Morrills Crossing Contract Rezoning

Application Review Correspondence

SUBJECT: Review of Sound Level Impact Assessment Report

RE: Landscape Peer Review- Response to Resubmission 2/17/06

Proposed Amenities and Snow Storage Plan

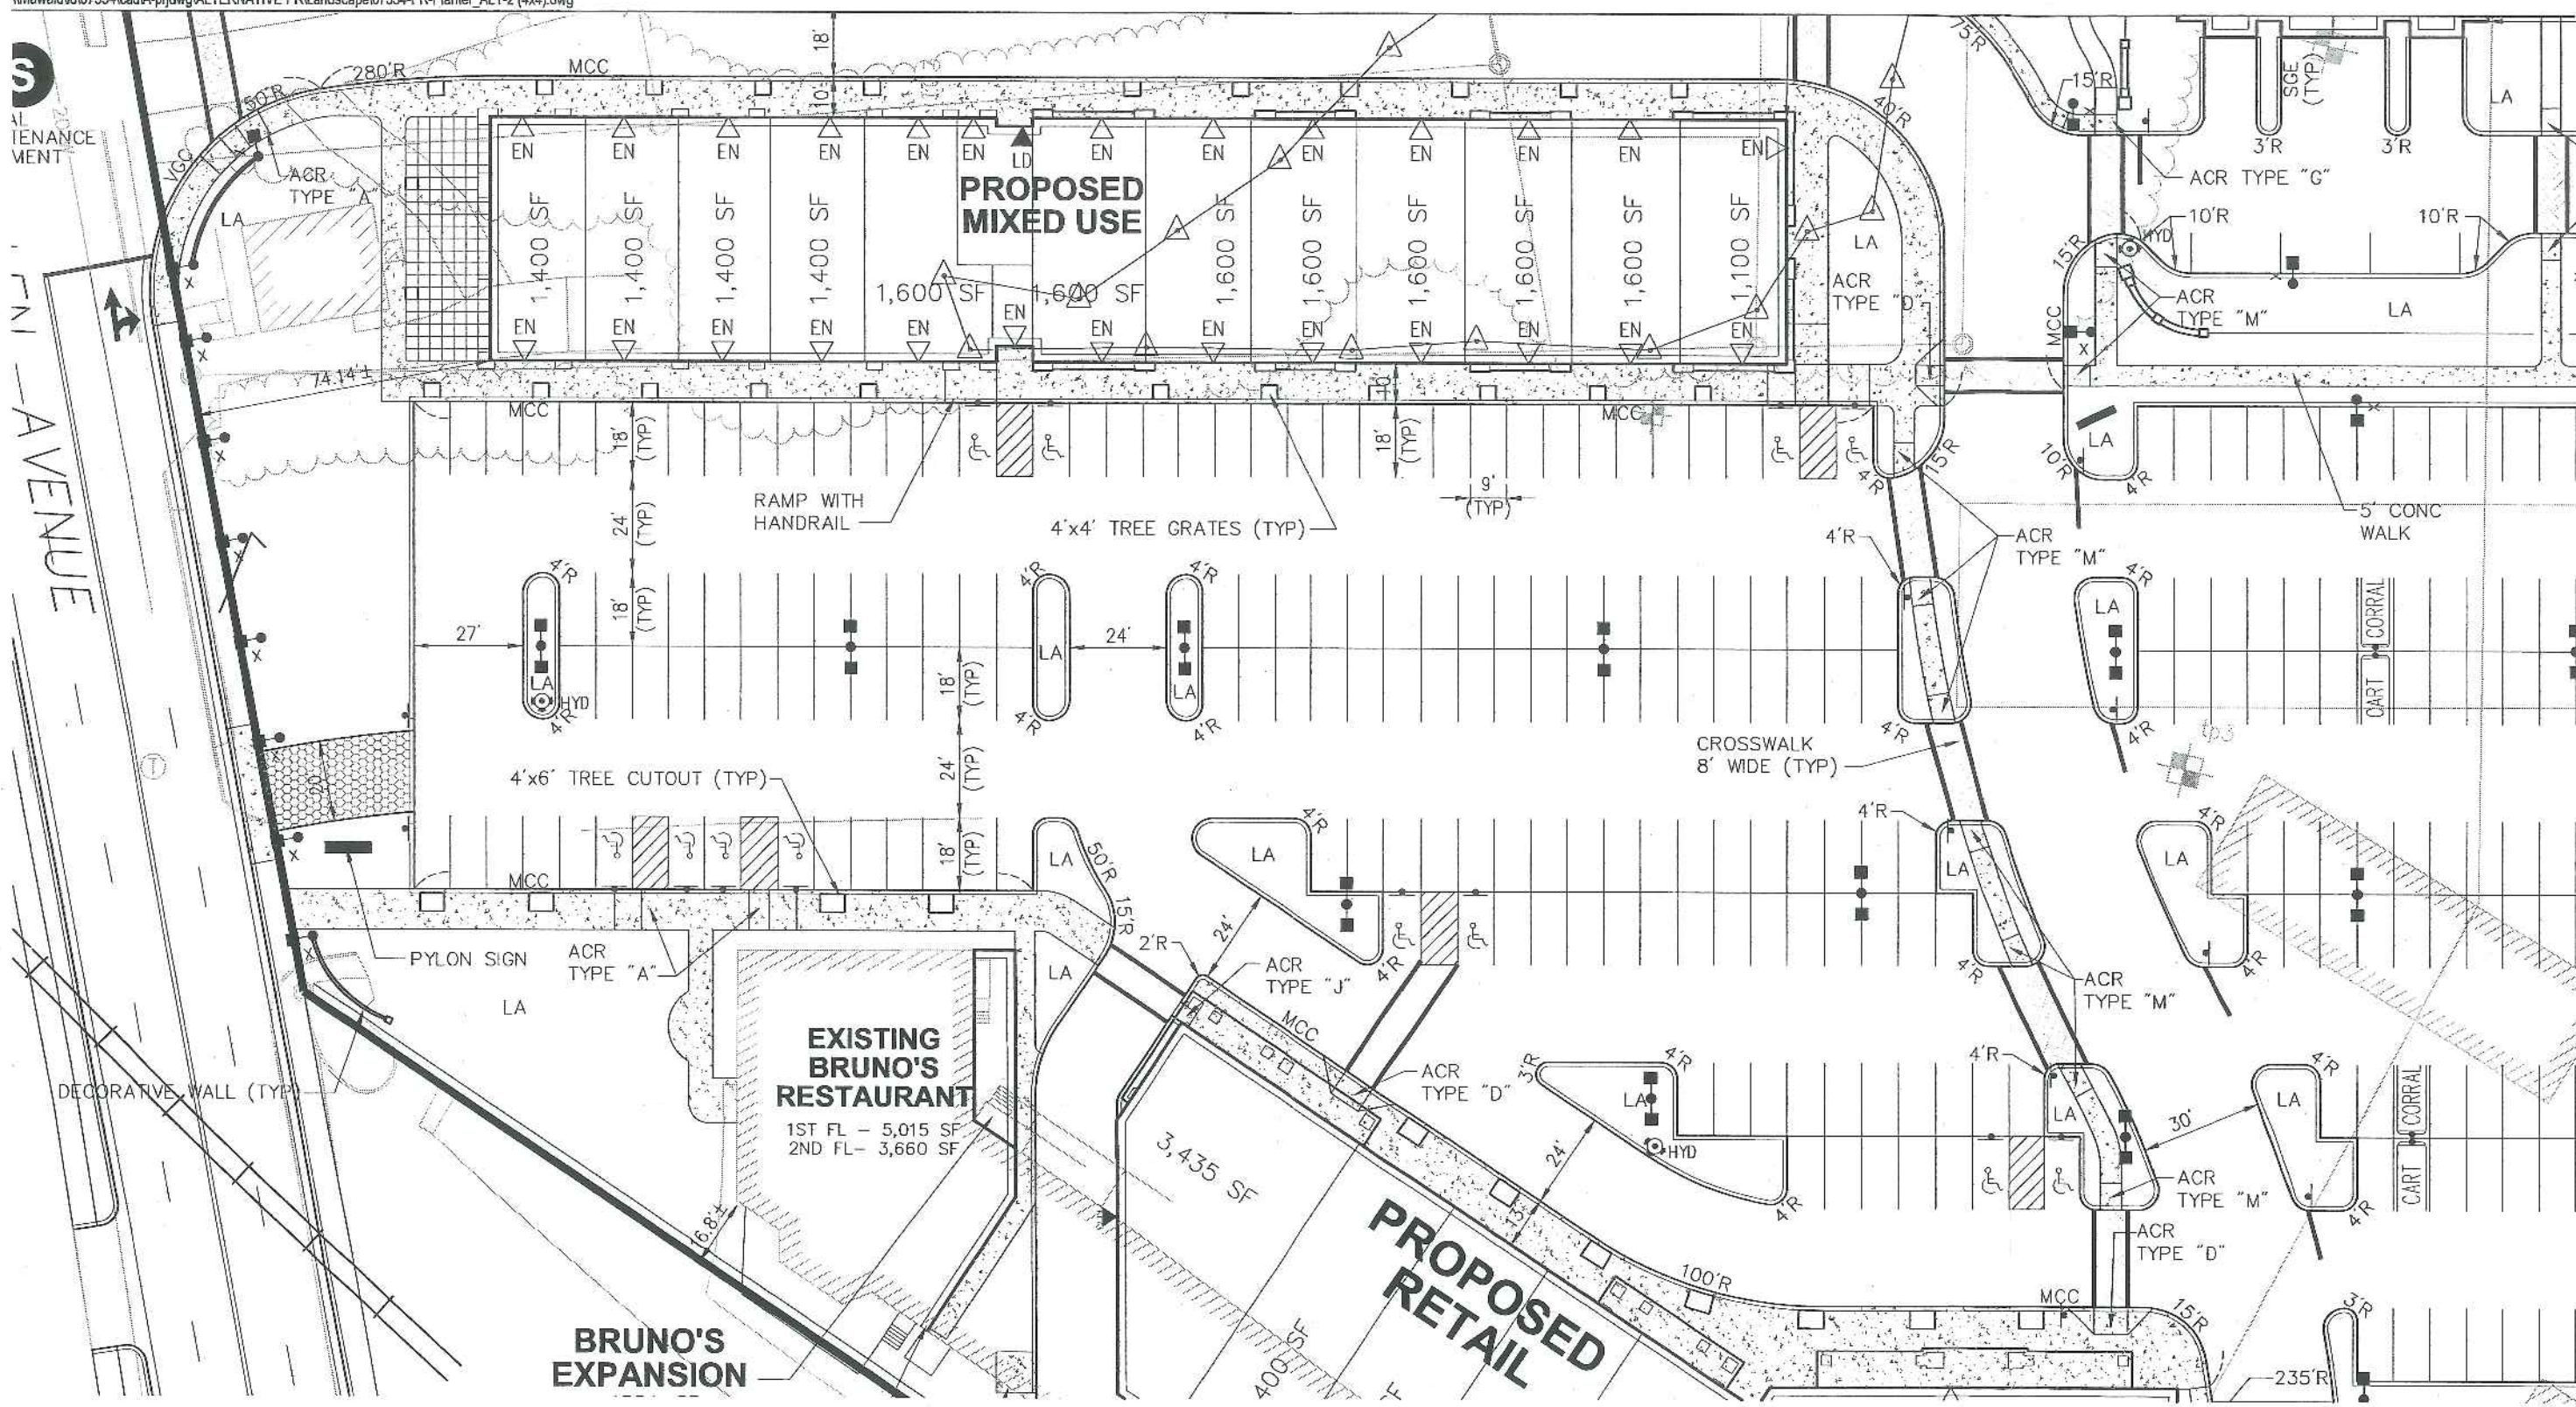
Snow storage areas are not indicated on the landscape Plan and we have concerns regarding the ability to protect the extensive landscaping in the medians and islands from snow damage.

It is unclear whether benches, bike racks, soccer goals, waste receptacles, and other site improvements are proposed and where they are to be located on the site. There are several areas where such furnishings seem appropriate and would add to the pedestrian and recreational use of the property.

Snow storage areas have been delineated on the Proposed Amenities and Snow Storage Plan included as Attachment D. Again, as discussed at our April 12th meeting, we agree that although the project includes approximately 7 acres of green/open space, the extensive landscaping limits the availability of snow storage areas. The areas identified on the attached plan will provide storage for the smaller snow storm events. The applicant agrees and commits to dispose of excess snow off-site.

Benches, bike racks, and trash receptacle locations are shown on the Proposed Amenities and Snow Storage Plan included as Attachment D. As requested by the Parks Department, no trash receptacles have been provided in the area of the recreation field. Also, at the request of the Parks Department, the applicant has agreed to provide a drinking water fountain located adjacent to the field.

Alternative Planter Exhibit
Morrill's Crossing
Portland, Maine
4-4-06

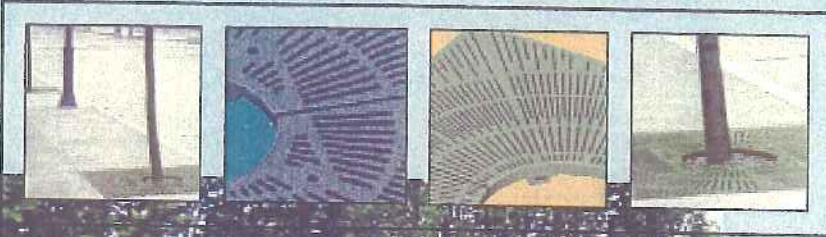
The Applicant has proposed to increase the cutout size from 3' x 3' to 3' x 12' with the cutout area containing perennials and concrete pavers. No detail has been shown for this configuration, but we have several concerns regarding its viability. The trees proposed are 3-3.5" caliper Maples and Ornamental Pears, which have a minimum root ball size of 32-38" according to ASNS which sets standards for nursery stock. Standard tree planting practice requires a tree pit excavation up to two times the root ball diameter, so it is unclear how these trees can be planted in such a restricted area (36"). It is also unclear how concrete pavers are integrated into the cutout area, what type they are, and whether they really will provide a pervious paving conducive to water infiltration or rather become mostly impervious as they typically do. It is noted that there are porous paver products available that may be suitable in this application. The Applicant is encouraged to research the viability of these products. It has also been the recommendation of the City Arborist in the past that tree cutouts be raised with curbing to better protect the trees from road salts and compaction.

As agreed at our meeting on April 12th, the 3'x12' tree planting cutouts in the area of the Bruno's and the adjacent Retail have been replaced by flush 4'x6' tree cutouts. In the area of the Proposed Mixed Used Building, 4'x4' ADA compliant tree grates are proposed. A cut sheet of the ADA compliant grate, as well as an updated layout plan, has been included as Attachment B.

ALTERNATE SITE LIGHTING & PHOTOMETRICS PLAN

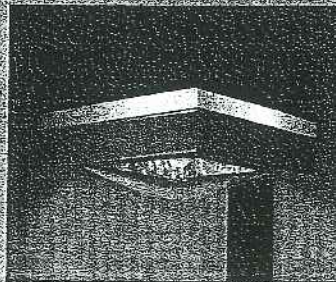
- 3. Site Lighting-** We have not received a revised Site Lighting Plan and still have concerns regarding the level of lighting on the north side of the supermarket, as well as hours of use for the site lighting, especially at the service area.

We have not received a revised Site Lighting Plan and still have concerns regarding the level of lighting on the north side of the supermarket, as well as hours of use for the site lighting, especially at the service area.

Responses to Mr. Carroll's Site Lighting Plan peer review comments have been submitted under a separate cover.
